DART AEROSPACE LTD		Work Order: 97411
Description: Crosstube Assembly, Mid Fwd		Part Number: D206-667-147TRN
Inspection Dwg: D206-667-147 Rev: A		Page 1 of 2

DRAWING NO. D206-667-147
TITLE CROSSTUBE ASS'Y (206L MID FWD)
SCALE NTS

DRAWING NO. D206-667-147	TITLE CROSSTUBE ASS'Y (206L MID FWD)	REV. A	DART AEROSPACE LTD ENGINEERING ORDER		D.E.O. NO. D206-667-147-A-1	SHEET NO. SHEET 1 OF 1	SCALE NTS
DRAWN <i>q</i>	CHECKED <i>ASS</i>	MFG. APPR. <i>BS</i>	APPROVED <i>MD</i>		DE APPR. <i>BT</i>		
DATE 11.07.15	DATE 11.07.20	DATE 11.07.21	DATE 11/07/21		DATE 11.07.21

DRAWING NO. D206-667-147	TITLE CROSSTUBE ASS'Y (206L MID FWD)	REV. A	DART AEROSPACE LTD ENGINEERING ORDER		D.E.O. NO. D206-667-147-A-2	SHEET NO. SHEET 1 OF 1	SCALE NTS
DRAWN AJS	CHECKED	MFG. APPR.	APPROVED	DE APPR.			
DATE 12.08.02	DATE 12.08.02	DATE 12.08.02	DATE 12.08.02	DATE 12.08.02	DATE 12.08.02

DETAIL P
BONDING STRAP INSTALLATION 2 PL

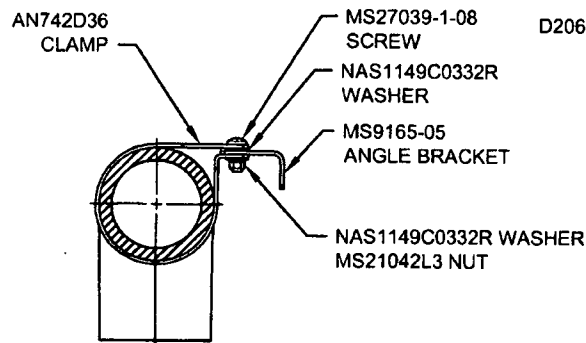
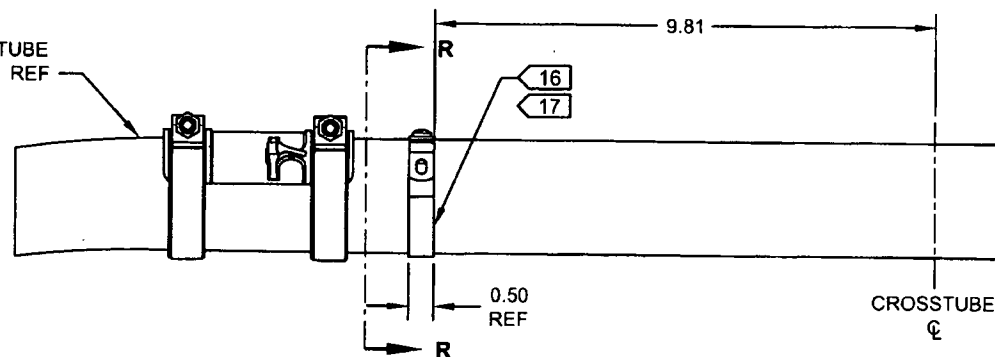
PURPOSE:

ADD ELECTRICAL GROUNDING STRAP

ITEM	QTY	PART NUMBER	DESCRIPTION
1	X	D206-667-147	CROSSTUBE ASSEMBLY (206L MID FWD)
10	2	AN742D36	CLAMP
11	2	MS9165-05	ANGLE BRACKET
12	2	MS21042L3	NUT (OR MS21042-3)
13	2	MS27039-1-08	SCREW
14	4	NAS1149C0332R	WASHER (OR AN960C10L)

- 16) MASK AREA UNDER CLAMP PRIOR TO PAINTING
- 17) SEAL EDGES WHERE AN742D36 CLAMP MEETS WITH THE CROSSTUBE USING SIKAFLEX-241/-291 OR MIL-S-8802 CLASS B2 OR PROSEAL 890 SEALANT
- 18) PERFORM RESISTANCE CHECK TO ENSURE MAX RESISTANCE IS 10 MILLIOHMS
